Access Compliance Report

Public Rights-of-Way

(Curb Ramps)

Intersection ID: 27197	Main Street: BALLANTYNE COMMONS PY	Cross Street: CRESTWOOD DR	Location: SE
ADA ID: 8D9AB8D625CD	Ramp Type: Perp	Initial Pass/Fail: Fail	Overall Compliance: No
Severity Score: 22.5			
Codes/Mitigation Info/Possible Solution		Field Measurements/Component Compliance

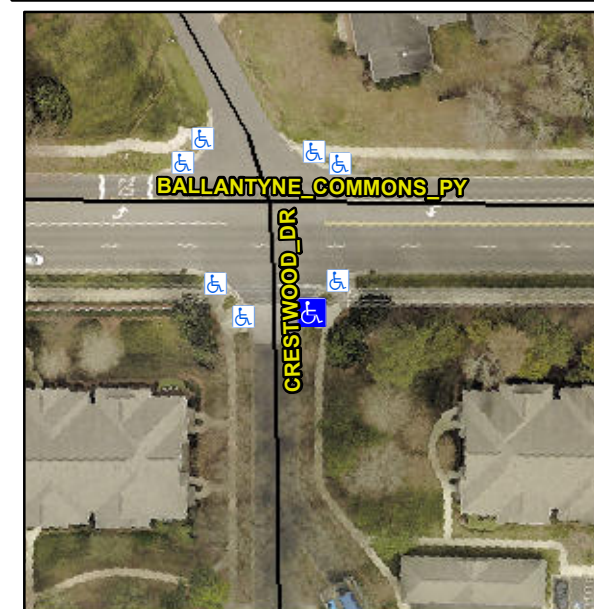
R304.5.1, R304.2.2, R304.5.3

Compliance	Description	Data	Compliance	Description	Data
N/A	Ramp Length (in)	98.0	No	Ramp Slope (%)	9.5
No	Ramp Width (in)	41.0	No	Ramp XSlope (%)	3.8
N/A	Flare Type LT	N/A	N/A	Flare Type RT	N/A
N/A	Flare Slope LT (%)	N/A	N/A	Flare Slope RT (%)	N/A
N/A	Flare Traversable LT?	N/A	N/A	Flare Traversable RT?	N/A
N/A	Landing Length (in)	N/A	N/A	DWS Provided?	N/A
N/A	Landing Width (in)	N/A	N/A	DWS Contrast?	N/A
N/A	Landing Slope (%)	N/A	N/A	DWS Length (in)	N/A
N/A	Landing X Slope (%)	N/A	N/A	DWS Full Width?	N/A
N/A	Landing Curb? (Y/N)	N/A	N/A	DWS Offset (in)	N/A
N/A	Shared Landing?	N/A			
N/A	Gutter Ponding?	N/A	N/A	Gutter Slope (%)	N/A
N/A	Gutter Lip Ht (in)	N/A	N/A	Gutter X Slope (%)	N/A
N/A	Painted X Walk1?	No	N/A	Painted X Walk2?	N/A
	X Walk 1 Direction	To W		X Walk 2 Direction	N/A
N/A	X Walk 1 Width (in)	N/A	N/A	X Walk 2 Width (in)	N/A
	X Walk 1 Slope (%)	0.4		X Walk 2 Slope (%)	N/A
	X Walk 1 X Slope (%)	4.2		X Walk 2 X Slope (%)	N/A

Remove & Replace Entire Ramp.
